From: Kitchen, Robert [robert.kitchen@pgnmail.com]
Sent: Sunday, July 08, 2012 7:50 PM
To: Habib, Donald
Cc: Waters, David; Keenan, Christopher; NPD Document Control Inbox
Subject: FW: Digitized CEUS SSC FIRS and revised FSAR Figures 2.5.2-355, -357, and -358
Attachments: FSAR_Table_2_5_2-236_DRAFT.pdf; LNP_FSAR_Rev5_FIG02_05_02_357_DRAFT.pdf; LNP_FSAR_Rev5_FIG02_05_02_358_DRAFT.pdf; LNP_FSAR_Rev5_FIG02_05_02_355_DRAFT.pdf

Don – Attached is the following DRAFT information for discussion at the next Levy COLA public call:

**Levy Nuclear Plant
Units 1 and 2
Part 2, Final Safety Analysis Report**

FIGURE 2.5.2-357

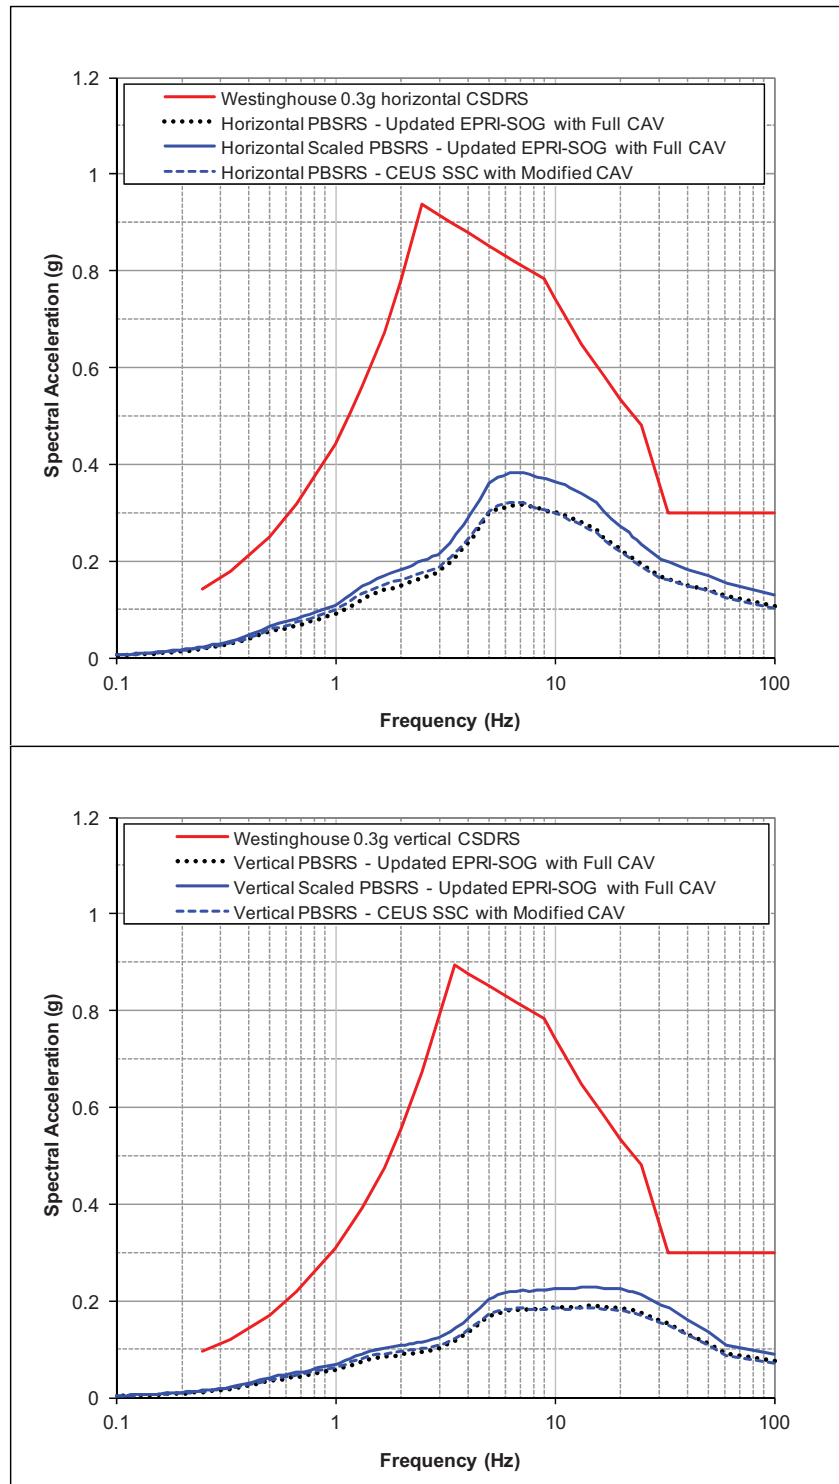
- FSAR Table 2.5.2 – 236 with digitized CEUS FIRS
- FSAR Figures 2.5.2 - 355, 357, and 358. Revised draft figures show the unscaled Updated EPRI SOG GMRS, PBSRS, and FIRS respectively.
